ADDENDUM NO. 1 – January 8, 2025

Mossdale Park Renovation – CIP PK 24-04
Valverde Park Renovation – CIP PK 25-01

HEET TITLE
MOSSDALE LANDING
PARK -
SITE CONSTRUCTION
PLAN

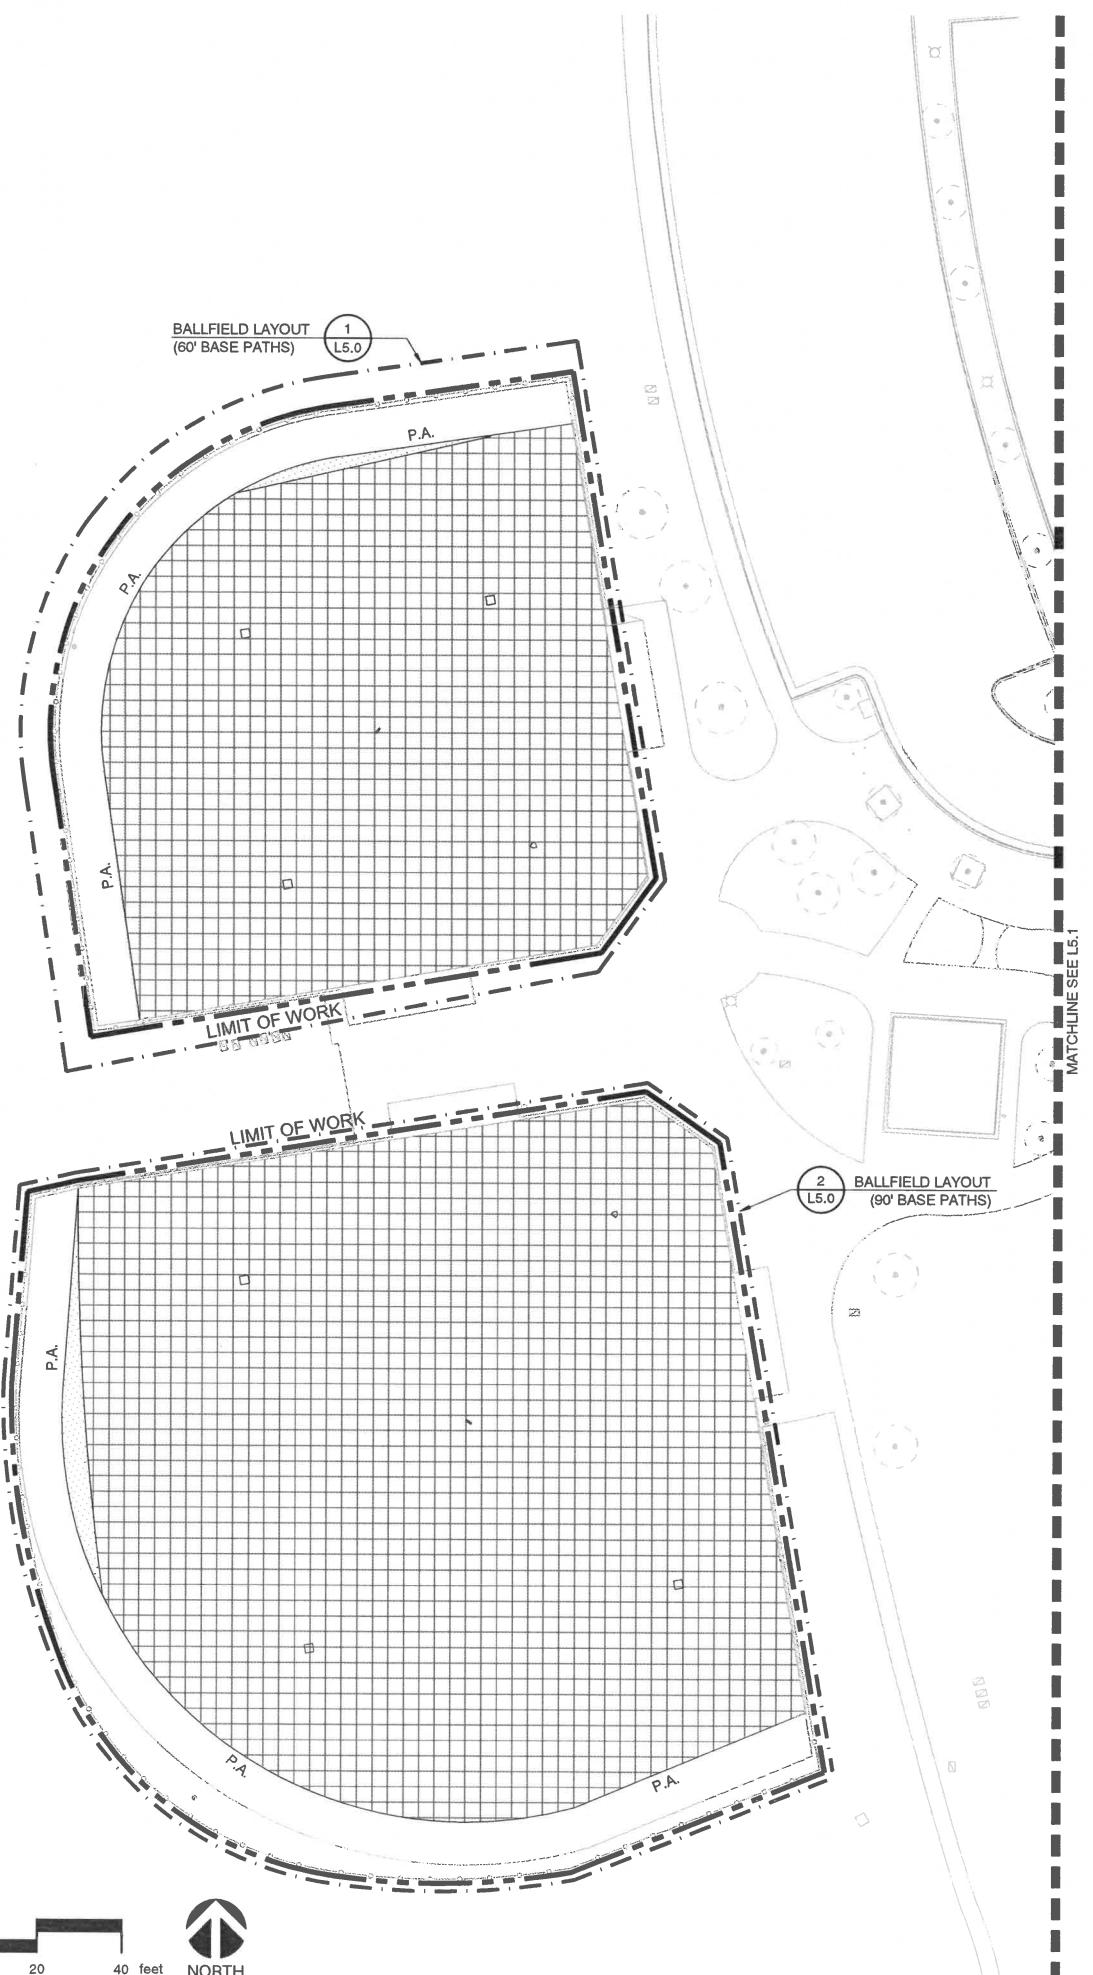
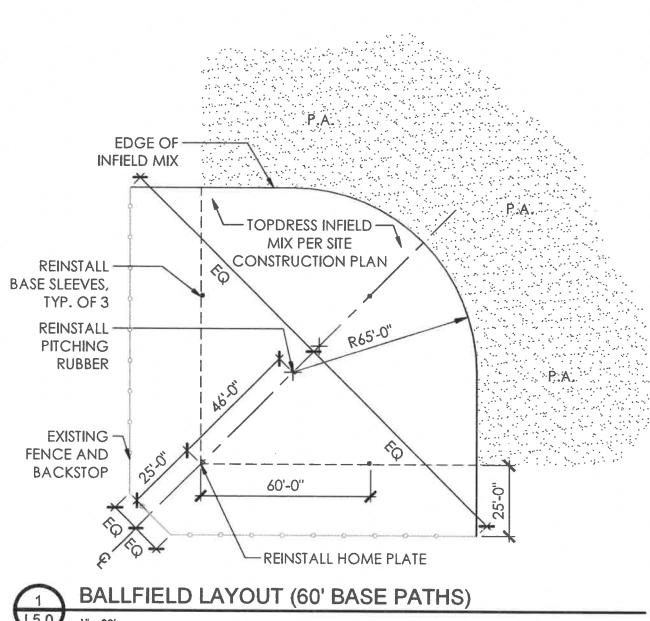
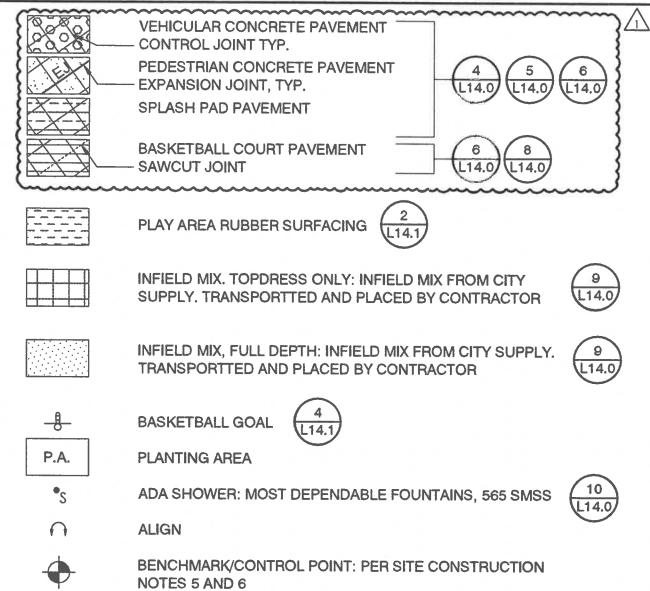
RFI 6: I'm reaching out in regards to question about the section for the basketball court. The detail shows 4" for Splash pad, and no AB for the pedestrian concrete. Would this section be considered pedestrian?

RFI 7: I actually just noticed the basketball court detail is actually detail 8/L14.0. It shows sports court pavement there but does not reference this detail anywhere.

A6: The section for the basketball court pavement shall be per detail 8 on sheet L14.0. Site Construction Legend on Sheets L5.0 and L5.1 updated to refer "Basketball Court Pavement" to detail 8/L14.0. Detail 8 on Sheet L14.0 will be renamed "Basketball Court Pavement", Sawcut Joint detail reference added to Site Construction Legend.

SPLASH PAD ENLARGEMENT - VALVERDE PARK

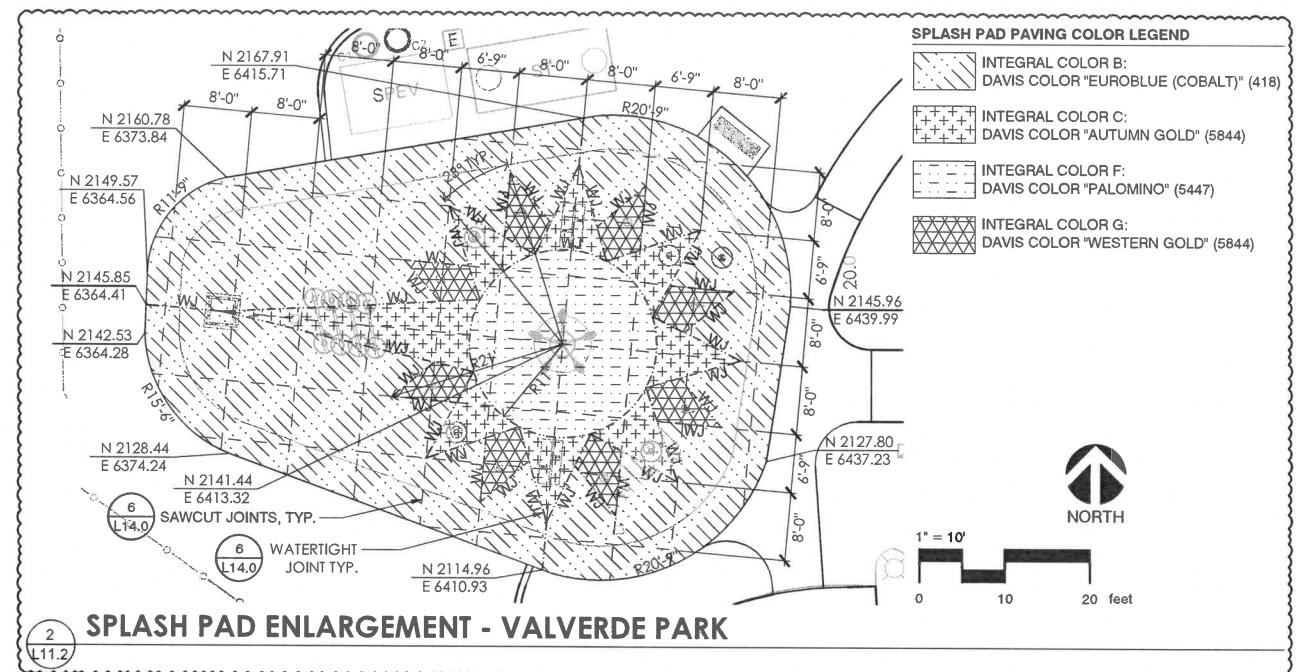
SHEET L11.2 – ENLARGEMENT 2/L11.2 (SPLASH PAD ENLARGEMENT VALVERDE PARK): Callouts identifying Sawcut Joints and Watertight Joints and associated details references added

ENTRY PLAZA PAVEMENT

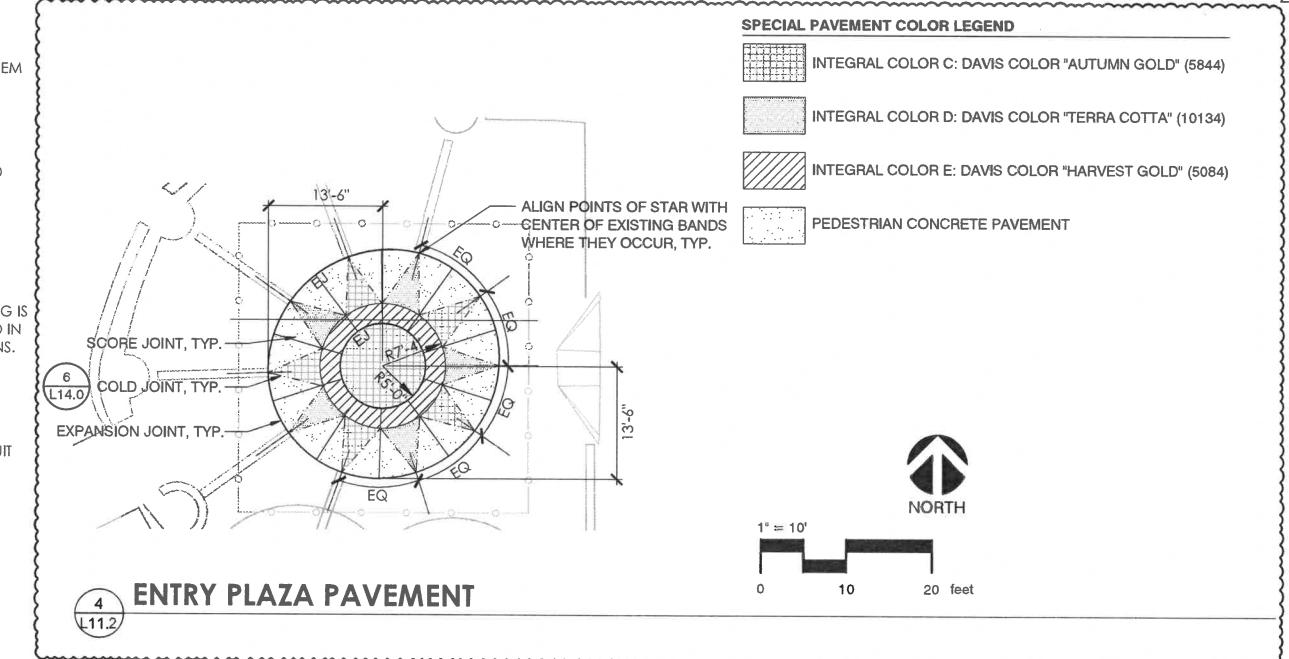
SHEET L11.2 – ENLARGEMENT 4/L11.2 (ENTRY PLAZA PAVEMENT): Removed extraneous circle linework.
